**CITY OF MUSKEGON
HISTORIC DISTRICT COMMISSION
REGULAR MEETING**

DATE OF MEETING: Tuesday, December 3, 2019
TIME OF MEETING: 4:00 p.m.
PLACE OF MEETING: **Conference Room 203, City Hall**

III. NEW BUSINESS

Proposed location and view of sign rendering from corner of W. Webster and Third Street

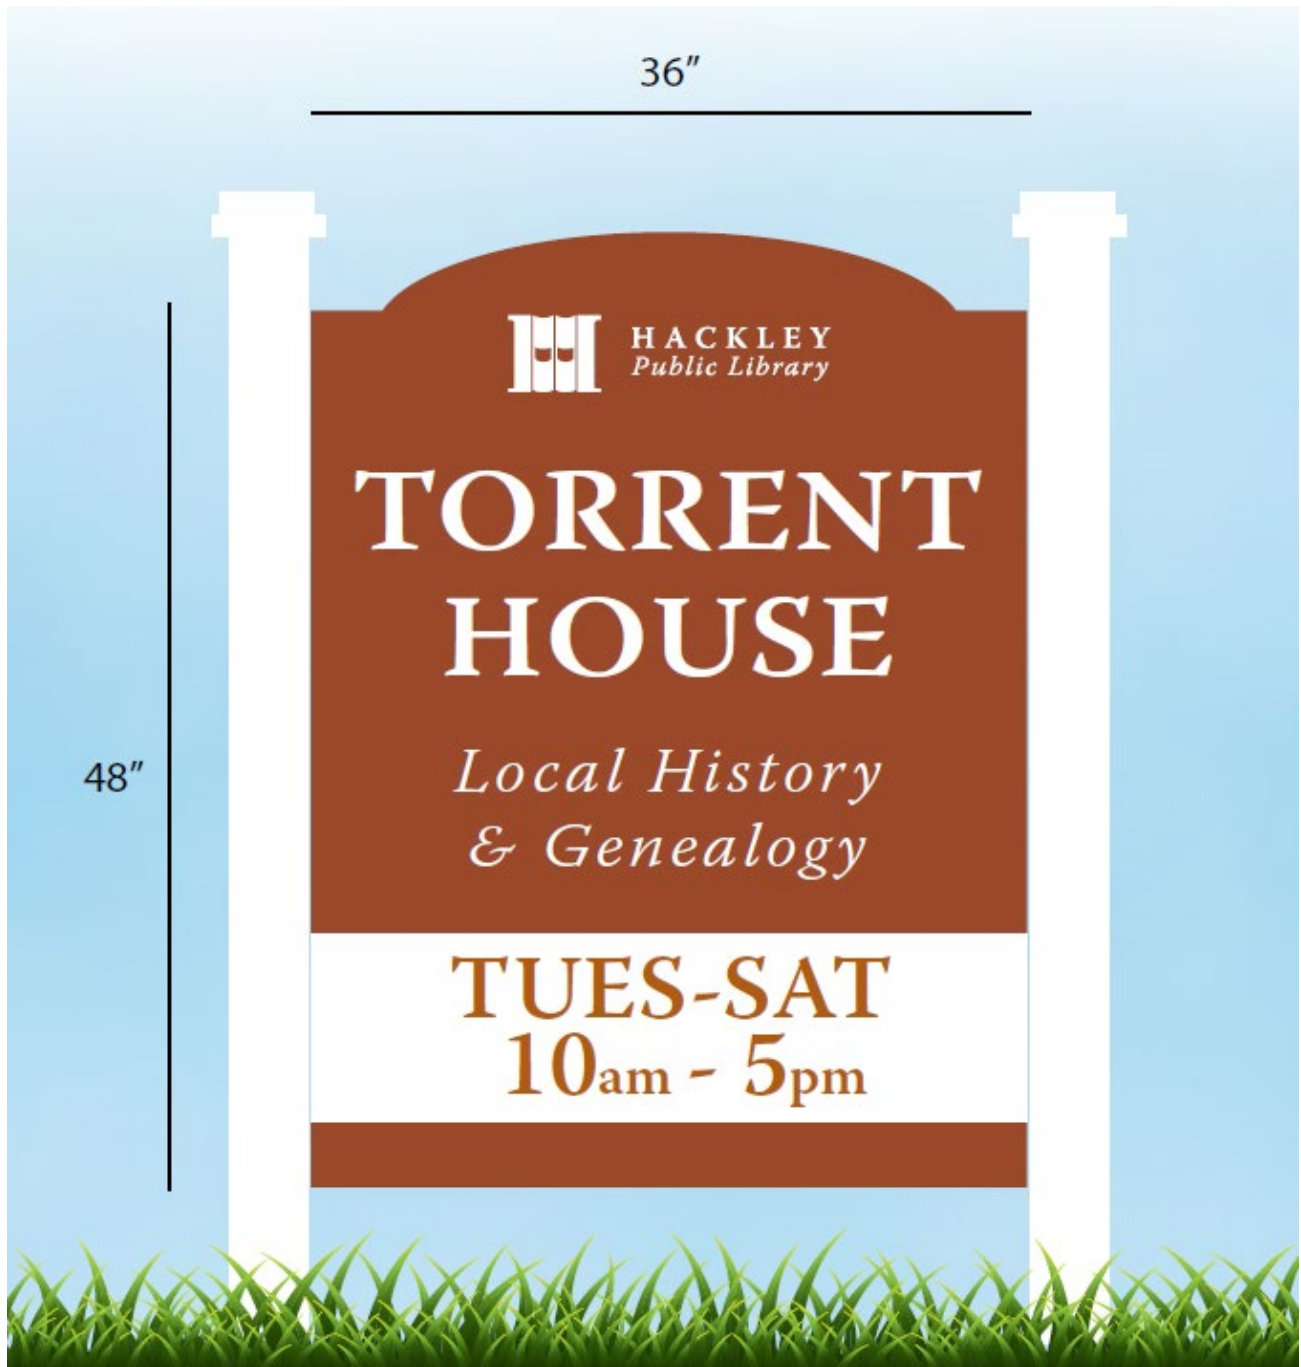
The applicant is seeking approval to install a new, 36” wide by 48” tall aluminum panel ground sign supported by 4” x 4” wood posts in the yard facing the intersection of W. Webster Avenue and Third Street.

I move that the HDC (approve/deny) the request to install a new, 36" wide by 48" tall aluminum panel ground sign supported by 4" x 4" wood posts in the yard facing the intersection of W. Webster Avenue and Third Street as long as the work meets all zoning requirements and the necessary permits are obtained.

View of house from W. Webster Ave. Picture window visible to the right of the front door

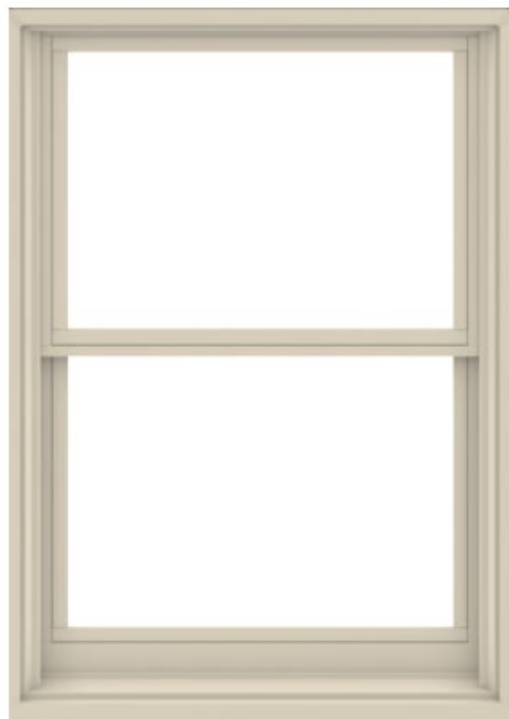
The applicant is seeking approval to remove and replace five wood windows on the house (one 53"x77" picture window on the front façade, and four 29"x70" double hung windows on the second floor) with vinyl windows. The applicant is also requesting to remove and replace four basement windows with new windows.

I move that the HDC (approve/deny) the request to remove and replace five windows on the house (one 53"x77" picture window on the front façade, and four 29"x70" double hung windows on the second floor) and to remove and replace four basement windows with new windows as long as the work meets all zoning requirements and the necessary permits are obtained.
